Document control desk
License Amendment Request R-2 Docket 50-005

REACTOR BAY HEATING AIR CONDITIONING, VENTILATION AND EXHAUST MODIFICATION DESCRIPTION

TECHNICAL SPECIFICATION CHANGE DETAIL AND JUSTIFICATION

Figure 6-1 Reactor Bay HVAC and Emergency Exhaust Systems

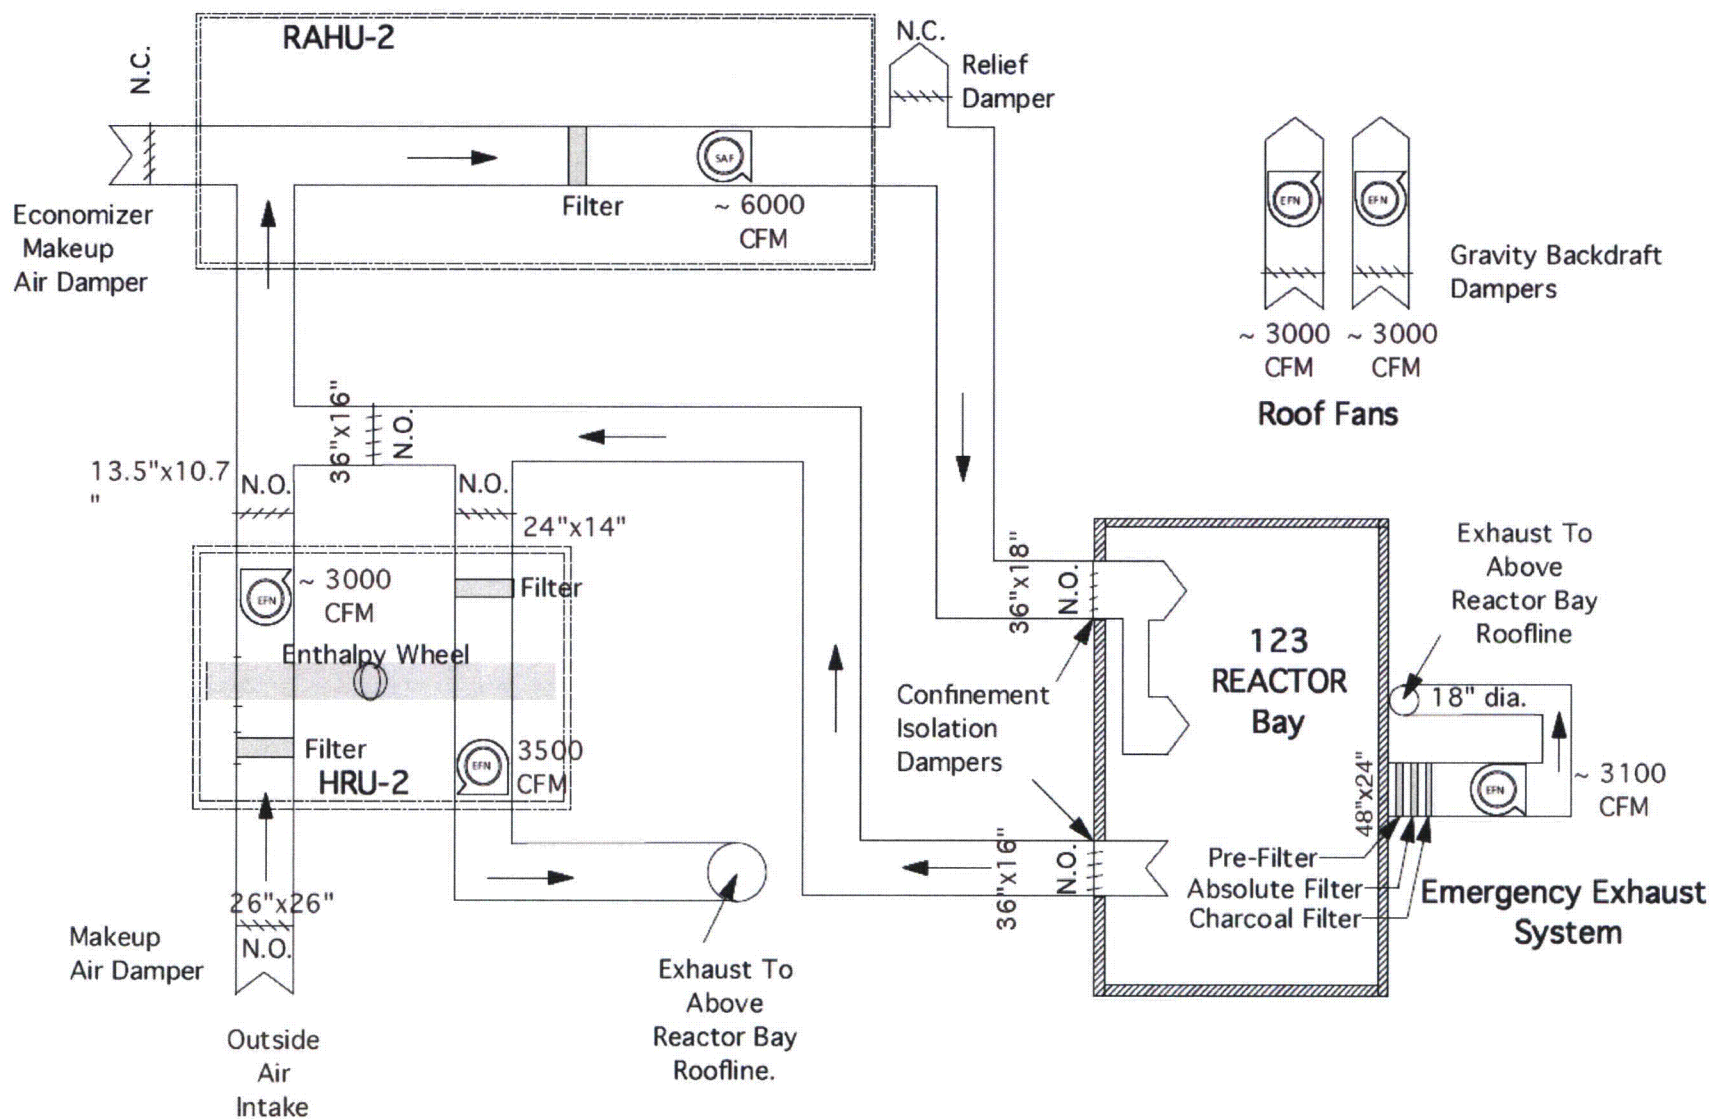
The ~70,000 feet³ (1900 m³) minimum volume reactor bay is maintained at a negative pressure with respect to the remainder of the building by one or more of four separate exhaust fans (see **Figure 6-1**). Depending on operational configuration, fresh air to the reactor bay is supplied by leaks around doors and penetrations and by the supply air fan. Normal heating, cooling, ventilation, and negative pressure of the reactor bay is maintained by the RBHVES. A filtered emergency exhaust system (EES) is also available.

When the evacuation alarm system is activated, any operating RBHVES fans are shutdown, associated confinement isolation dampers shut, and the EES system starts. The EES creates sufficient negative pressure in the reactor bay so that any movement of radioactive material from the bay would be through the system filters. Air enters the EES through a screened opening in the east wall of the reactor bay about ~14 feet (~4 m) above the bay floor (see Figure 6-2 EES System). The air then passes through a pre-filter, absolute filter, and carbon filter that are mounted in a housing on the roof of the east extension of the reactor bay. The exhaust fan (~3100 feet³/min or $\sim 9.1 \times 10^4$ l/min with system dampers completely open) is also mounted there. Flow can be reduced through the system by adjusting the manual dampers. Filtered air exhausts into an 18 inch (46 cm) diameter PVC pipe and stack. The stack travels up the east outside wall of the reactor building and exhausts at a point above the reactor bay roof (~34 feet above reactor bay floor level).
